# ROADWAY AND STORM SEWER CONSTRUCTION PLANS FALCON MEADOWS AT BENT GRASS FILING NO. 4 FALCON, CO 80831 - EL PASO COUNTY CHALLENGER COMMUNITIES, LLC

$\sim$ PCD-ENGINEERING REVIEW COMMENTS IN BLUE BOXES WITH BLUE TEXT

# Construction Drawings (PlansProfiles)\_v1.pdf Markup Summary 8-29-2022

**PLANS**

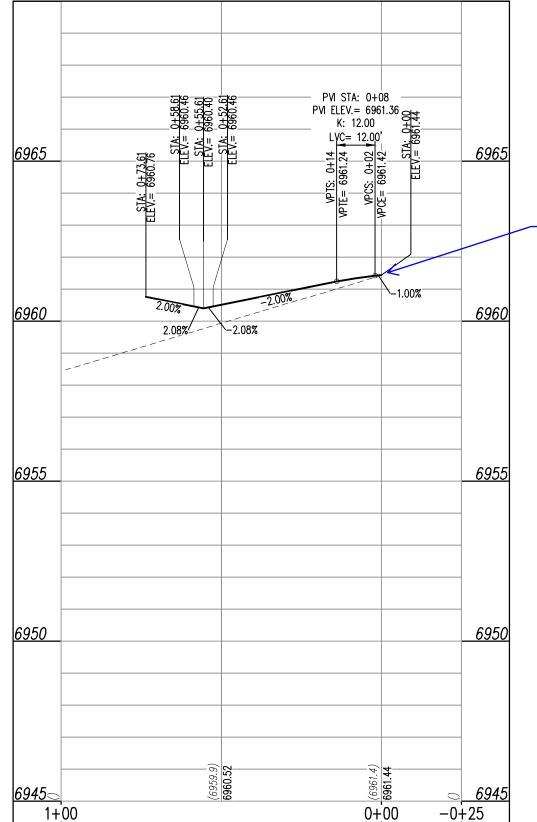
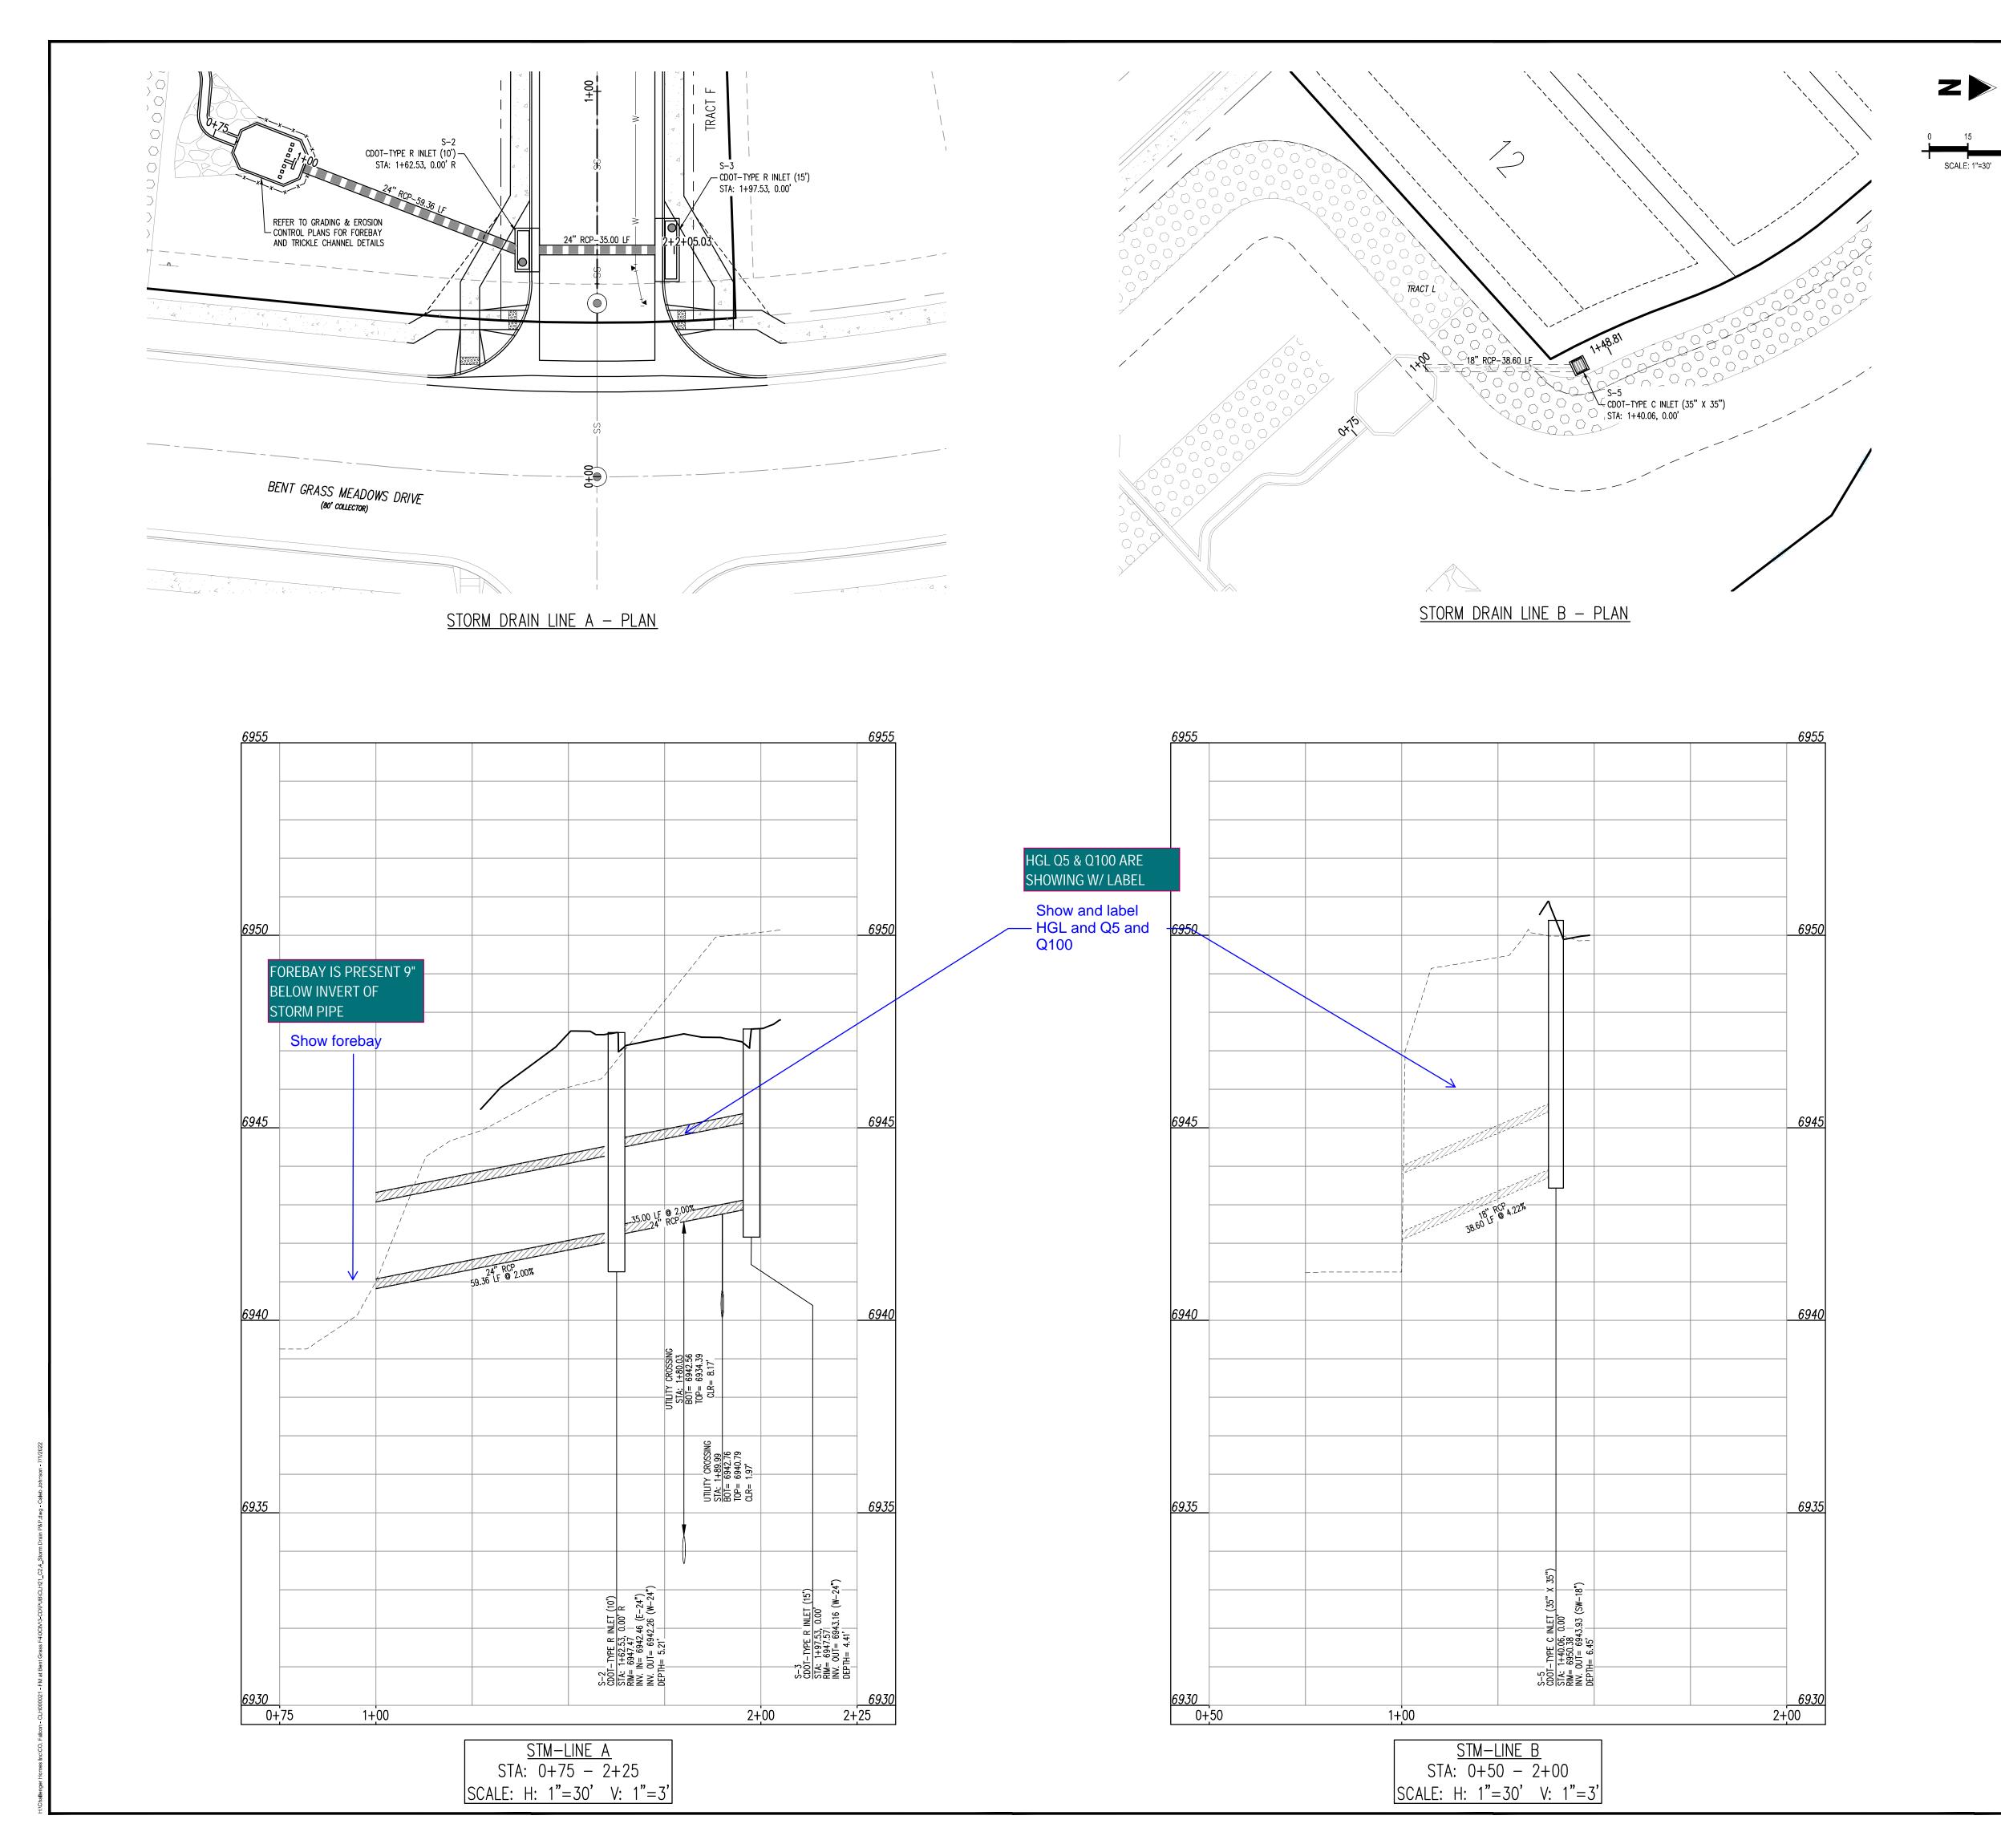
Show and label

grade; revise

Show and label the existing 3% grade; revise
